Recommendation to Hold a Public Hearing and Approve the West Ketchum Residences Townhome Preliminary Plat

A PLAT SHOWING WEST KETCHUM RESIDENCES

IN RE:)
)
West Ketchum Residences) KETCHUM CITY COUNCIL
Townhouse Subdivision Preliminary Plat) FINDINGS OF FACT, CONCLUSIONS OF LAW, AND
Date: March 16, 2020) DECISION
)
File Number: 19-141)

PROJECT: West Ketchum Residences Preliminary Plat

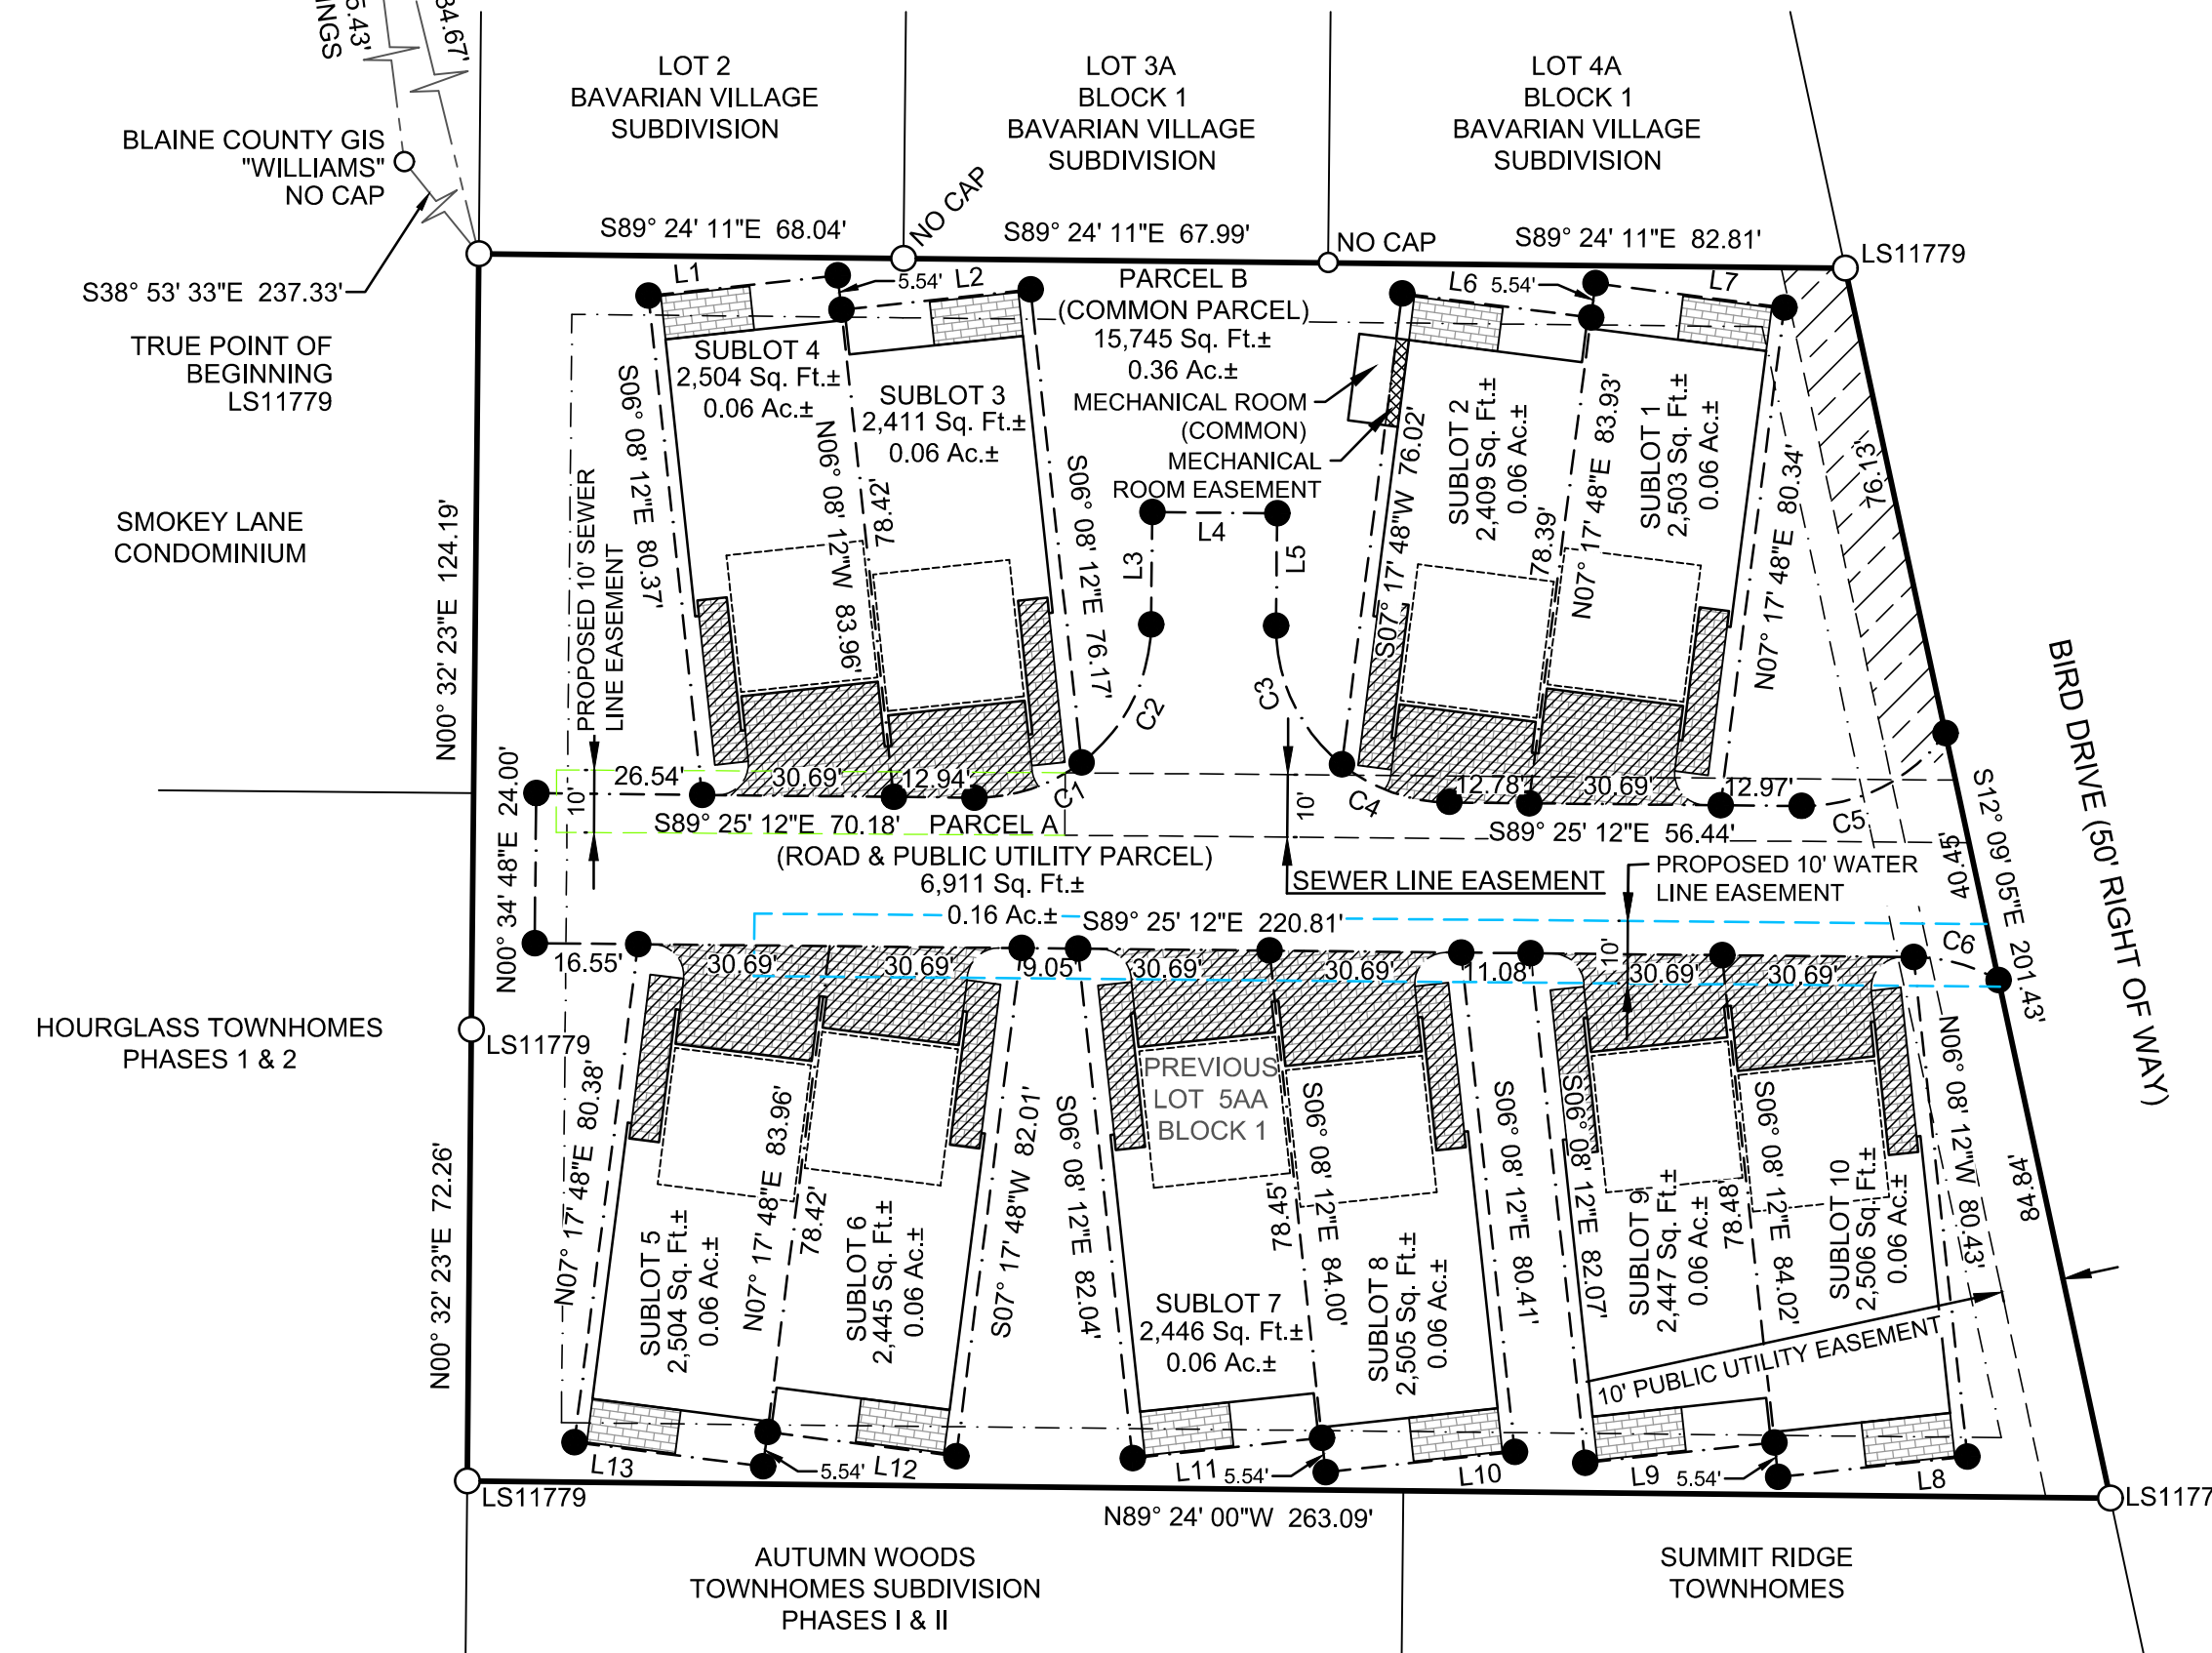
<p>right-of-way for construction including the closure of adjacent streets or sidewalks requires a Temporary Use of Right-of-Way Permit ("TURP").</p> <p>7. Final civil drawings for all associated ROW improvements shall be submitted with the Building Permit application to be verified, reviewed, and approved by the City Engineer and Streets Department prior to issuance of a Building Permit for the project.</p>
<input checked="" type="checkbox"/>	<input type="checkbox"/>	<input type="checkbox"/>	<p>Utilities:</p> <ol style="list-style-type: none"> All existing water services on the property will be cut and capped at the main. Any abandoned sewer service lines will be cut and capped at the property line. All water mains and services are private. Maintenance and repairs are the responsibility of the property owner or association. All townhomes will have separate service lines, individual meters, vaults, and own irrigation systems to be confined to the specific sub lot. A separate meter and tap will be needed for the common area for irrigation and billed through the association. Each subplot and common area will be assessed connection fees for both water and sewer. The exception is the common area will only pay a water connection fee. The sewer main will be public, placed in a utility easement no less than 10ft wide. Should repairs be required on any part of the public sewer main the City of Ketchum will not be responsible for repair or replacement of pavers, landscaping, or heating system. Plat notes depicting a public sewer main shall be shown on the final plat with the description listed in note 8. A description of the private water main shall be shown on the final plat as described in note 3.

Findings	As conditioned by the utilities department, the following plat notes shall be added to the Final Plat: <ul style="list-style-type: none"> All water mains and services are private. Maintenance and repairs are the responsibility of the property owner or association. Should repairs be required on any part of the public sewer main the City of Ketchum will not be responsible for repair or replacement of pavers, landscaping, or heating system. All other standards have been met.
<input checked="" type="checkbox"/>	<input type="checkbox"/>	<input type="checkbox"/>	16.04.030.J .11	The location, approximate size and proposed use of all land intended to be dedicated for public use or for common use of all future property owners within the proposed subdivision.
			Findings	Common areas are indicated on the plat – Parcel B, common lawn area, and Parcel A – road and public utility parcel.
<input checked="" type="checkbox"/>	<input type="checkbox"/>	<input type="checkbox"/>	16.04.030.J .12	The location, size and type of sanitary and storm sewers, water mains, culverts and other surface or subsurface structures existing within or immediately adjacent to the proposed sanitary or storm sewers, water mains, and storage facilities, street improvements, street lighting, curbs, and gutters and all proposed utilities.

1. The following notes shall be added to the Final Plat:
 - a. All water mains and services are private. Maintenance and repairs are the responsibility of the property owner or association.

- b. Should repairs be required on any part of the public sewer main the City of Ketchum will not be responsible for repair or replacement of pavers, landscaping, or heating system.

4. The recorded plat shall show a minimum of two Blaine County Survey Control Monuments with ties to the property and an inverse between the two monuments. The Survey Control Monuments shall be clearly identified on the face of the map.
